RE: Hayward Park Review

Plan Review Comments
HAYWARD PARK
CANNON DESIGN GROUP
October 1, 2019

Preliminary Review Comments
HAYWARD PARK
CANNON DESIGN GROUP
June 21, 2019

SHEET 3

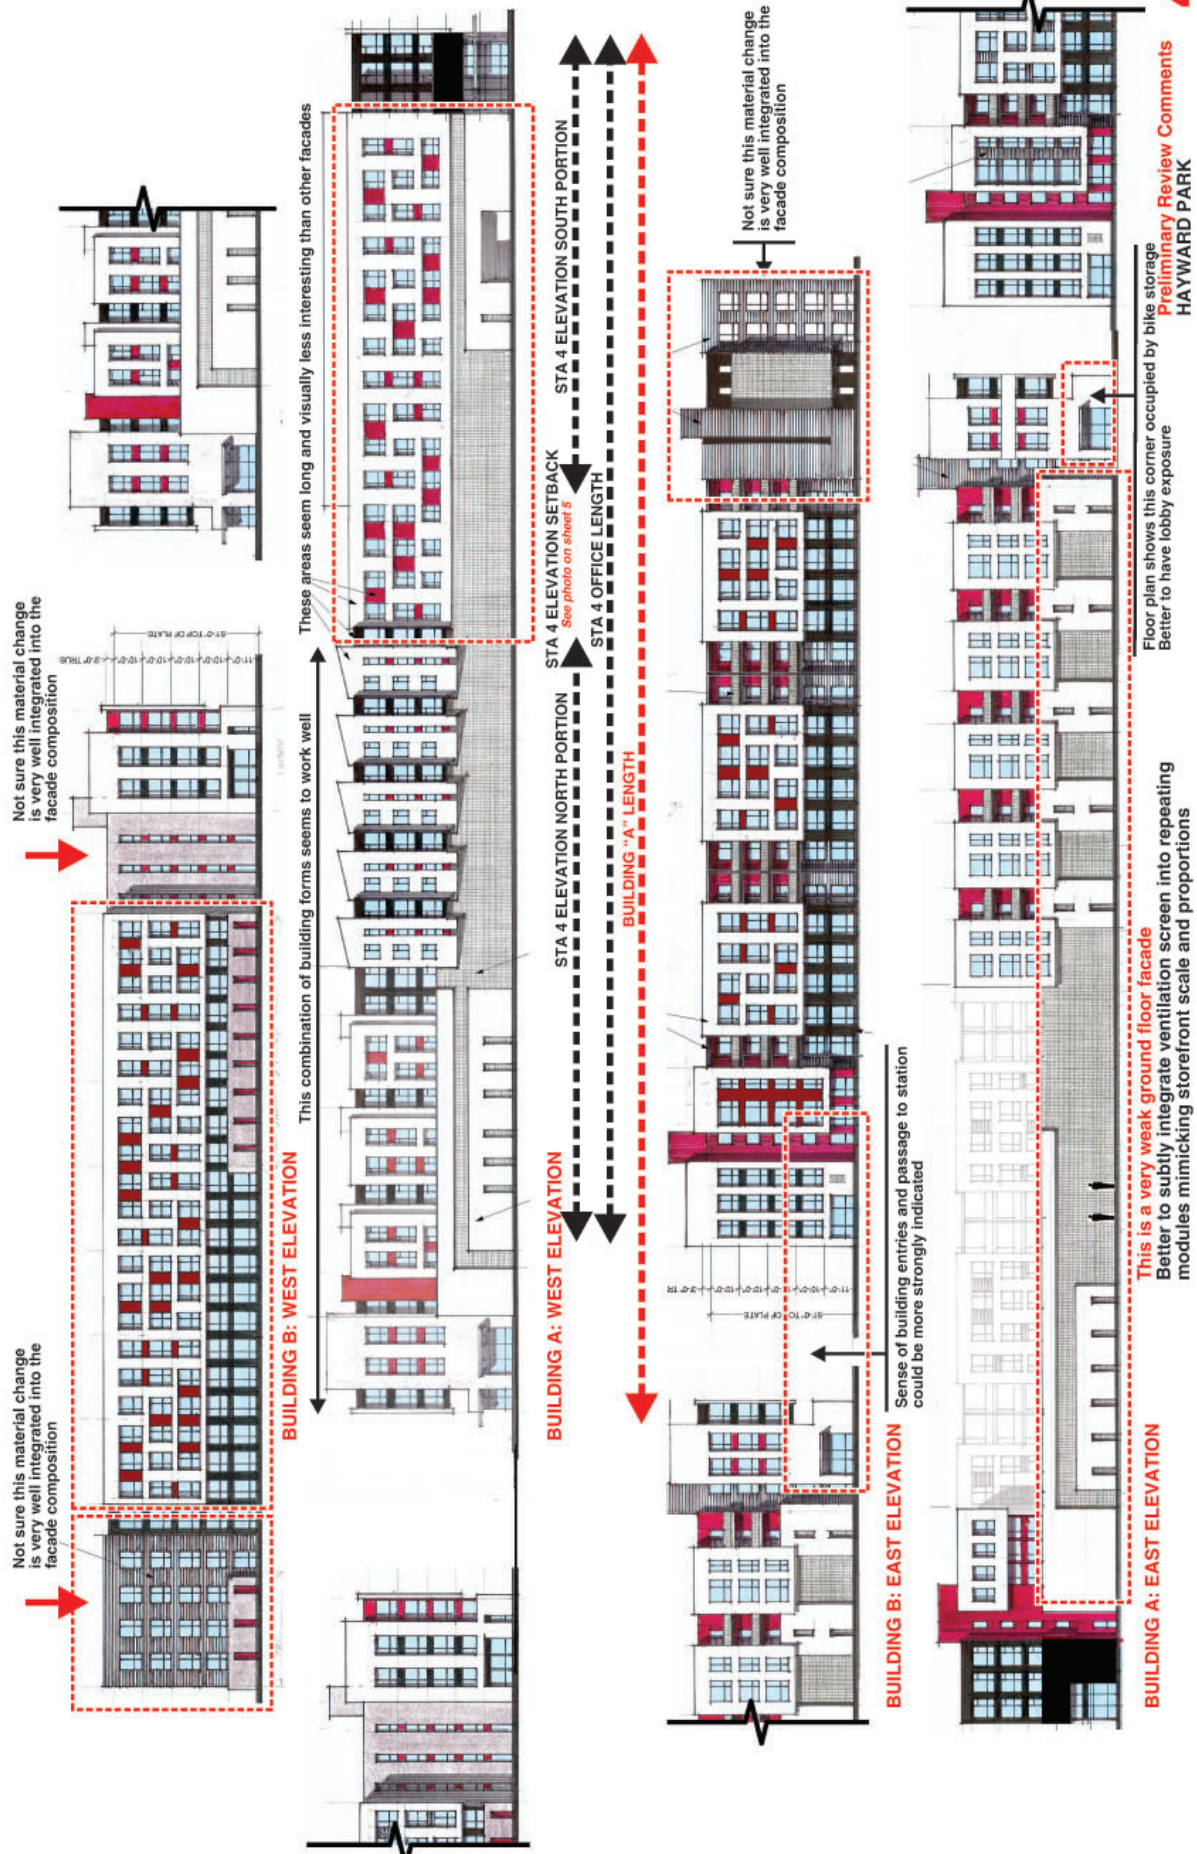
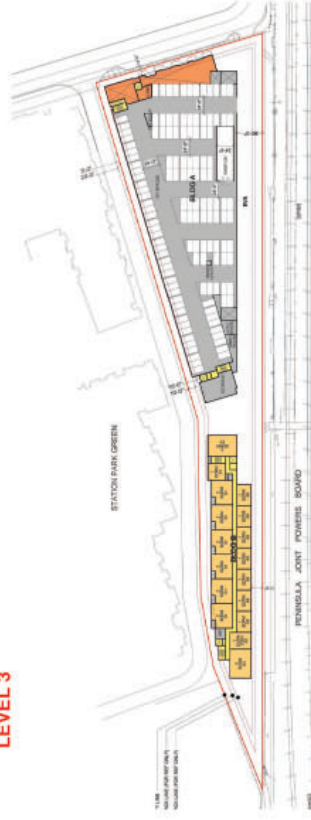
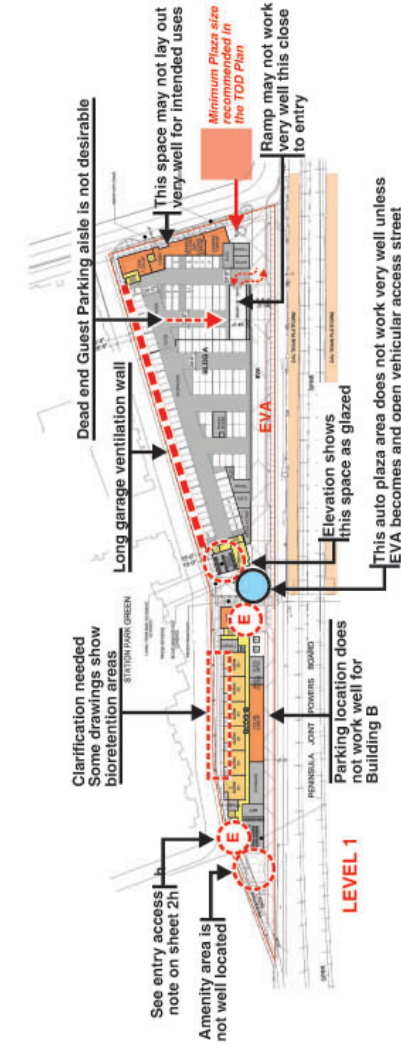
1. The Arrival Plaza at the southwest corner of Building A does not appear to correspond to the locational or minimum size guidelines set forth in the TOD Plan.

2. The third level podium open space amenity in Building A could work, but only if the two ground floors are designed to provide a more pedestrian friendly and visually inviting environment along the EVA edge - see the example photo at The Americana at Brand in Glendale.

3. The central service and fire truck turn around plaza area between Building A and B is only accessible via the limited access EVA along the western edge of the property. If the EVA on the east side does not allow free vehicular access to this area or the building entries along the Eastern side of the site, this service area would probably need to be opened up for access and treated as a major entry point to both buildings.

4. The parking garage is substantially oversized for the stated building requirement of 141 spaces, and seems somewhat inconsistent with a TOD project located immediately adjacent to the CalTrain Station and bus hub.

5. The parking ramp located very close to the garage entry may not work all that well, and its security gate located at the ramp access may impact parking ingress and egress.

6. The dead end parking aisle in the Guest Parking area is not very desirable.
7. Clarification is needed regarding the sidewalk, street trees and bioretention areas along the east frontage of Building B.

8. The intrusion of garage parking spaces adjacent to the commercial and amenity space along the Concar Drive frontage may make efficient utilization of that frontage difficult.

Elevated podium open space works OK if ground floor facade is well treated

Clarification needed
Some drawings show
bioretention areas

See entry access
note on sheet 2H
Amenity area is
not well located

Dead end Guest Parking aisle is not desirable

Long garage ventilation wall

This space may not lay out
very well for intended uses
*Minimum Plaza size
recommended in
the TOD Plan*
Ramp may not work
very well this close
to entry

Elevation shows
this space as glazed

This auto plaza area does not work very well unless
EVA becomes an open vehicular access street

Parking location does
not work well for
Building B
